Quest Engineering & Failure Analysis, Inc. www.quest-engineering.com

Re: Rebuttal Report

File: Bryson Accident

Quest No: 10519

Figure 2: Comparison of Maximum Engagement

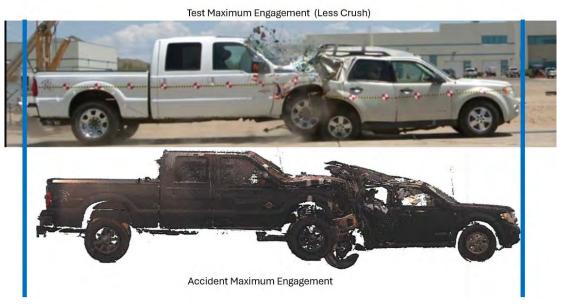
The point of maximum engagement between the **test** vehicles is in the crash test video. When comparing the crash test to the 3D model of the **accident** vehicles at maximum engagement, there was less penetration into the rear passenger compartment than on the accident Escape (*Figure 2*).

Figure 7: Longitudinal crash pulse comparison

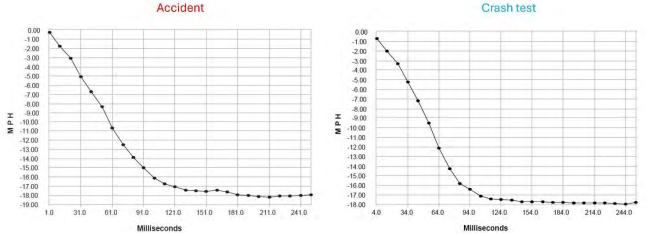
As identified above, the crash pulses of the **test** F250 and the **test** Escape can be compared with respect to generally accepted principles of classical physics and accident reconstruction. The two F250 crash pulses are shown below (*Figure 7*). In engineering, the rate of change of velocity is the acceleration and by Newton's Law of Motion is directly related to the applied force. Thus, the steeper the crash pulse, the greater the applied force. Since the test "change of velocity pulse" verses "time pulse" is steeper, it represents greater deceleration of the **test** F250 per unit time and thus greater applied force on the front of the truck to slow it down faster. The source of this force is, of course, the presence of the **test** Escape. Because there is a greater force in the test, the **test** Escape was stronger in the region impacted than in the accident even though there was less of the Escape available directly in front of the **test** F250 to resist the truck (because of the offset problem shown above). The steeper crash pulse does demonstrate that when impacted at the lower elevation, the Escape provides more resistance and therefore is stronger and because energy is the product of force and distance, the crush distance mathematically must be lower. Thus, just from the accelerometer data recorded in the **accident** and **test** F250's, and using physics, the lift kit resulted in an increased amount of **accident** Escape crush when compared to an impact with a non-lifted F250. The calculations are as follows:

- Accident F250 Crash Pulse slope from 31 ms and 5.10 mph to 91 ms and 14.96 mph is -7.5 g's
- Test F250 Crash Pulse slope from 34 ms and 5.24 mph to 94 ms and 16.42 mph is -8.5 g's
- **Test** Deceleration Minus **Accident** Deceleration equals one G (the weight an F250 or about 8500 to 9000 pounds)

Thus, when the lift kit was removed from the F250, the **test** Escape was able to generate about 8,500 to 9,000 pounds more force to resist crush than when struck by a lifted truck because the bumper level structures of the Escape were better engaged as it was a bumper-to-bumper level impact. The actual increase in resistive force would have been higher had the offsets been proper because there would have been more lateral overlap by 5 inches and thus even more of the Escape structure would have been directly engaged.
